## OFFICE OF COMMUNITY DEVELOPMENT

### STAFF UPDATE

**Re:** **UPDATE to Staff Review of** PUD-AP-2016-01 Amended PUD Petition and Revised Area Plan for Grandview Commons Mixed Residential Development, Revised Layout Plan and Parallel Plan dated June 1, 2016 and received June 2, 2016

**Date:** June 2, 2016

CLIENT NAME: MMB EQUITIES, LLC  
**GRANDVIEW COMMONS**  
 AREA PLAN  
 LAYOUT PLAN

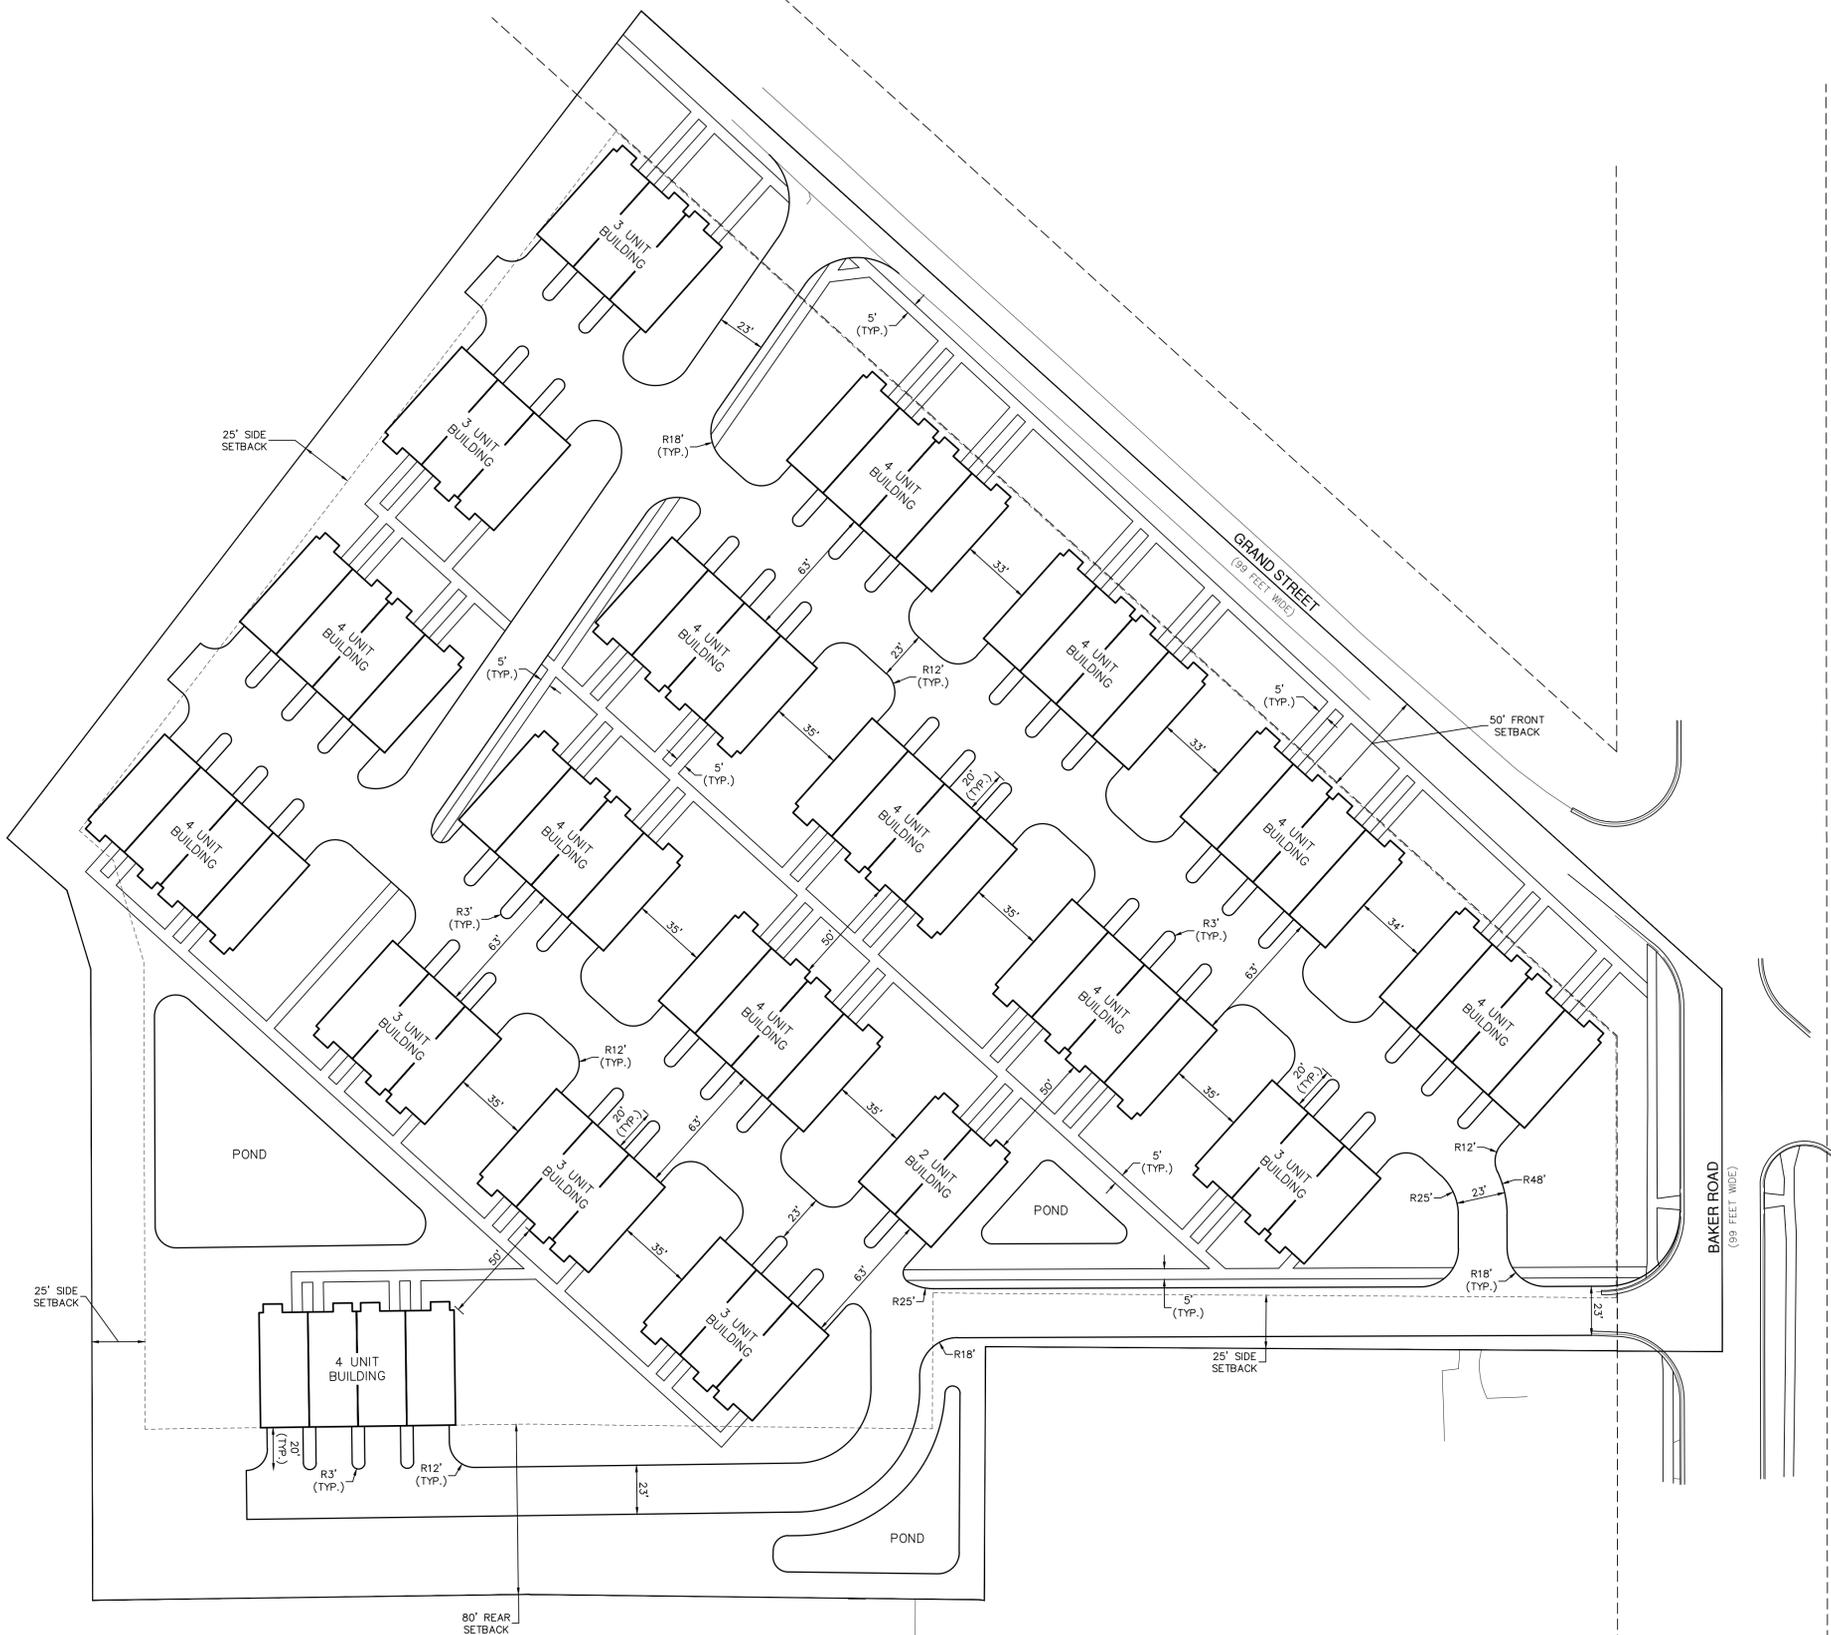
The applicant has submitted a revised layout plan and parallel plan, along with a response letter, based suggestions and recommendations of staff, the planning and engineering consultants, and the DAFD. Since the submittal arrived just as staff was preparing the Planning Commissions packet, a thorough review and analysis by staff, the planning and engineering consultants and the DAFD have not been conducted. However, the primary change to the plan centers on the elimination of an 8-unit building in the center of the development and the creation of a centralized communal green space. Other changes to the layout plan include the addition of a 4-unit building and 4 benches. The net change in the density is a loss of 4 units, which brings the total number of units proposed to 76, which is 9 units per acre.

3. Consider central open space.

7. Verify height of townhouse, duplex and 4-unit structures.

9. Reduce amount of guest parking or demonstrate the need for additional parking to Planning Commission.

10. Demonstrate barrier-free guest parking spaces in accordance with ADA requirements.

In an effort to provide centralized open space and more centrally located common space we have eliminated the central 8-unit building. Elimination of the middle building permitted us to create an additional ½ acre of centrally located common space with 4 additional benches, further reduce the projects impervious surface, and improve individual unit view sheds and spaces overlooking the park.

Unit Type	Height
Townhouses	30' 5 ¼"
8-unit	29' 5 ¼"
4-unit	29' 5 ¼"
Duplexes	17' 6 ½"

On-site guest parking spaces have been reduced to 13. The development has been revised to include 76 units. We feel as though 13 spaces are necessary for guests, mail delivery, and maintenance vehicle parking. We hope the Planning Commission will consider permitting at least 13 guest parking spaces.

2 barrier-free guest parking spaces have been added to the site plan.
